# Access Compliance Report

## Public Rights-of-Way

Intersection ID: 14846	Main Street: HENLEY_PL	Cross Street: S_KINGS_DR	Location: NW
ADA ID: 032455DD220F	Ramp Type: IslandPerp	Initial Pass/Fail: Fail	Overall Compliance: No
		Severity Score: 25

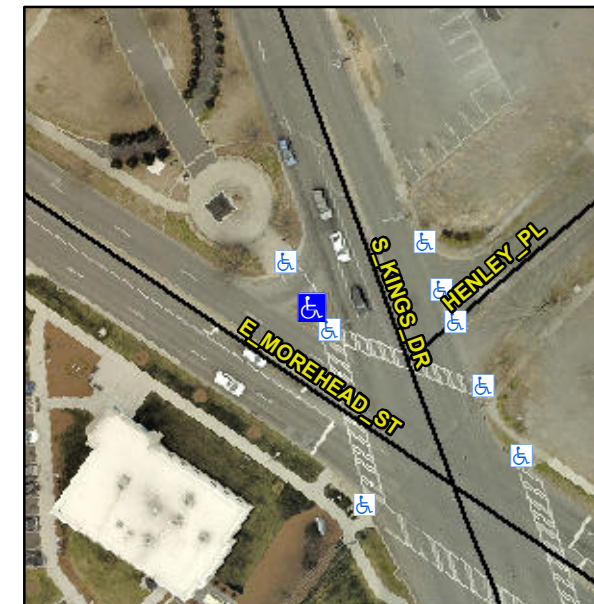
**Not Found, R304.2.2**

Compliance	Description	Data	Compliance	Description	Data
N/A	Ramp Length (in)	64.0	No	Ramp Slope (%)	12.8
Yes	Ramp Width (in)	48.0	Yes	Ramp XSlope (%)	0.7
N/A	Flare Type LT	N/A	N/A	Flare Type RT	N/A
N/A	Flare Slope LT (%)	N/A	N/A	Flare Slope RT (%)	N/A
N/A	Flare Traversable LT?	N/A	N/A	Flare Traversable RT?	N/A
N/A	Landing Length (in)	N/A	N/A	DWS Provided?	N/A
N/A	Landing Width (in)	N/A	N/A	DWS Contrast?	N/A
N/A	Landing Slope (%)	N/A	N/A	DWS Length (in)	N/A
N/A	Landing X Slope (%)	N/A	N/A	DWS Full Width?	N/A
N/A	Landing Curb? (Y/N)	N/A	N/A	DWS Offset (in)	N/A
N/A	Shared Landing?	N/A			
N/A	Gutter Ponding?	N/A	N/A	Gutter Slope (%)	N/A
N/A	Gutter Lip Ht (in)	N/A	N/A	Gutter X Slope (%)	N/A
N/A	Painted X Walk1?	Yes	N/A	Painted X Walk2?	N/A
	X Walk 1 Direction	To NW		X Walk 2 Direction	N/A
N/A	X Walk 1 Width (in)	112.0	N/A	X Walk 2 Width (in)	N/A
	X Walk 1 Slope (%)	2.9		X Walk 2 Slope (%)	N/A
	X Walk 1 X Slope (%)	1.0		X Walk 2 X Slope (%)	N/A

**Remove & Replace Entire Ramp.**
